SERVICE BULLETIN

REFERENCE	ENGINE
NUMBER	008
DATE	12-11-87
MODEL	AW16

SUPERCHARGED MR2 FUEL INJECTORS

Position of colored mark

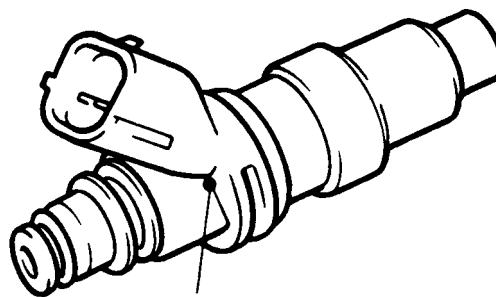
- Fuel Injectors are color coded according to flow rate and matched to the engine at the assembly plant.

Note: All four injectors installed on the engine must be of the same color coding.

- If replacement is necessary, replace with only an injector of the same color coding as that originally installed.

(Example, four yellow coded injectors cannot be substituted for four black coded injectors.)

- Location of injector color mark is shown in the accompanying illustration.

- Individual part numbers for injectors are as follows:

23209-16060 - 01 = Blue
23209-16060 - 02 = Black
23209-16060 - 03 = Yellow
23209-16060 - 04 = White
